MEMORANDUM

The project area is located at the mouth of French Coulee, in the NW1/4, SE1/4, Sec 26, T19N, R6E on the Belt, MT, 7.5 minute USGS topographic quadrangle (Figure 1). It lies approximately 0.5 miles south of Belt, Montana between Anaconda Road to the southwest and the Burlington Northern Railroad tracks to the northeast. Landowners include Mayme Ballatore and Mary and Ken Martin of Belt, Beatrice MacLeod of Langly, Washington, Harriet Stanton of Tulsa, Oklahoma and the Burlington Northern Railroad.

ATTACHMENT 2
CHANGE ORDERS

ATTACHMENT 5
AS-BUILT DRAWINGS

FRENCH COULEE WETLAND
 SUPPL. DWG. 1a: CELL 1 INFLUENT FLUME

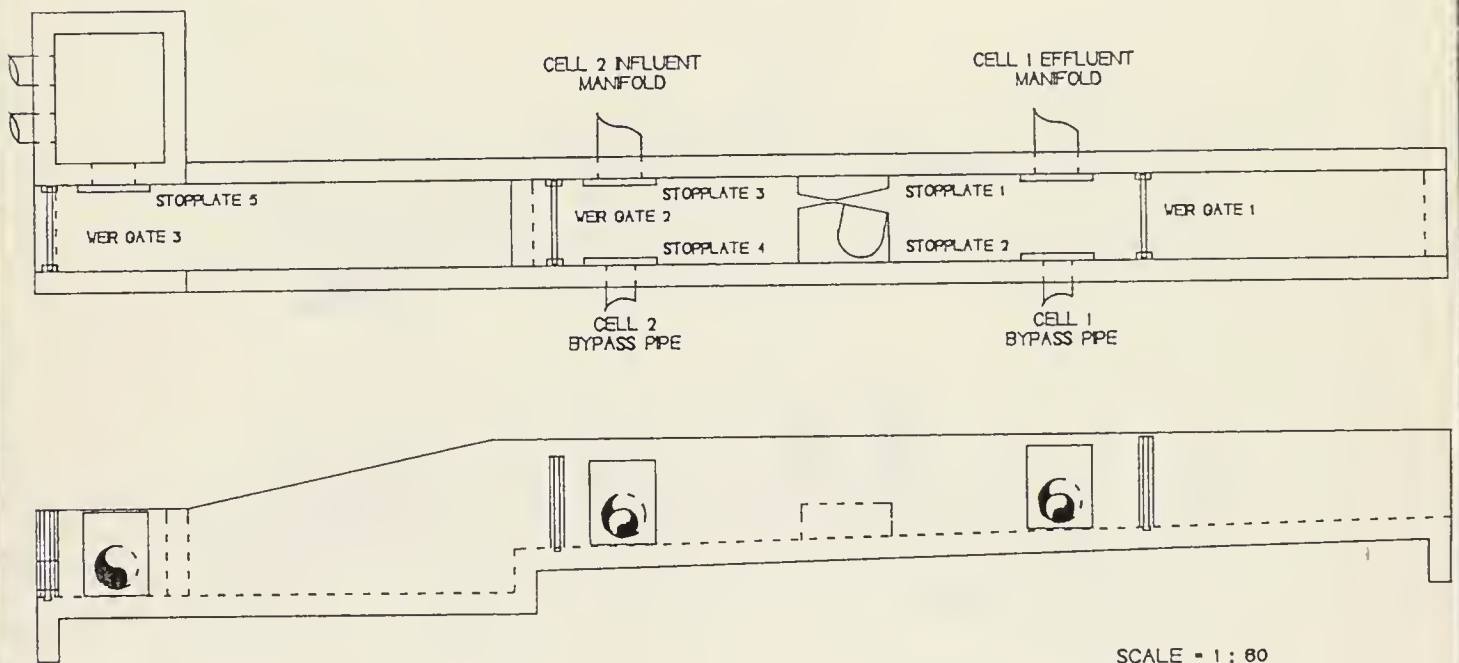
Description: 1) Build flumes and associated piping (manifolds, bypass, etc.) as shown on Supplemental Drawing 1a, 1b, 1c, and 1d. Change number of stopplates and other material quantities as per drawings.

PRESSURIZED CLEANOUT (TYPICAL of 10)
SHUT-OFF VALVE REQUIRED
(SEE SUPPLEMENTAL DRAWING 2 FOR DETAIL)

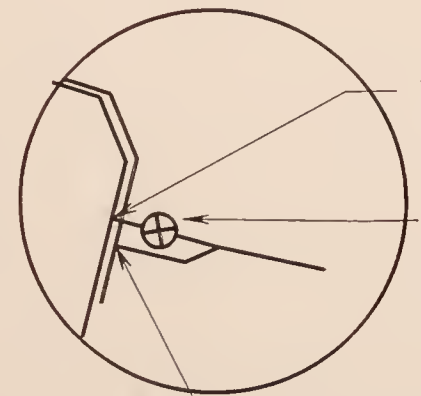
- Description:
- 1) Change location of 8" PVC main line as shown on Supplemental Drawing 2.
 - 2) Change 4" main cleanout design and location as shown on Supplemental Drawing 4.
 - 3) change from use of butterfly valves (2) to ten (10), 4" acid resistant ball valves as shown on Supplemental Drawing Nos. 2, 3, and 4.

- 1) To maintain designed head in main line, provide for easier access and cleanout of main line and reduce overall depth of main burial.
